SERVICE LETTER

No. 519

Subject: Replacement and Relocation of Alternator Ground Wire

Models Affected: PA-23-250 (Six Place) Aztec

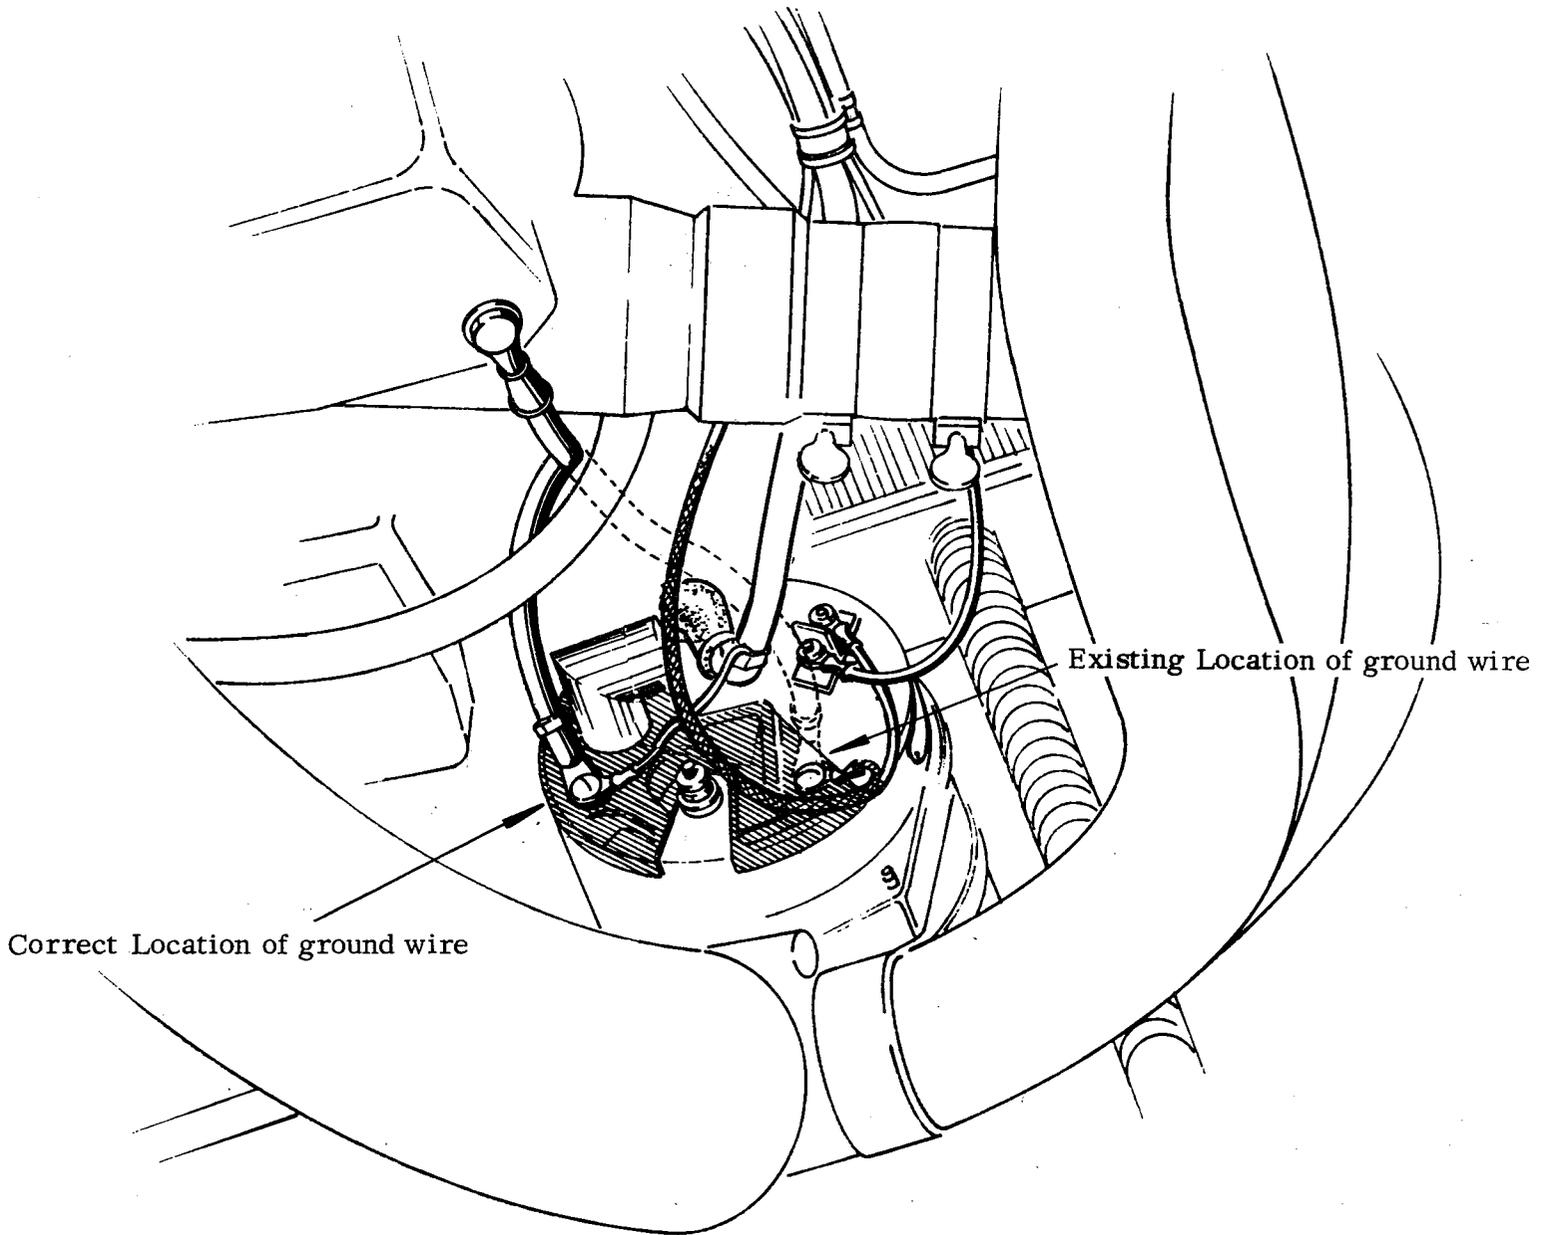
Purpose: To replace the existing alternator ground wire and relocate the ground wire attachment point on the alternator blast tube cover to insure a more positive alternator ground. (See sketch on reverse side of this letter for additional information.)

Instructions: Contained in Kit No. 760 282, Alternator Ground Wire Replacement
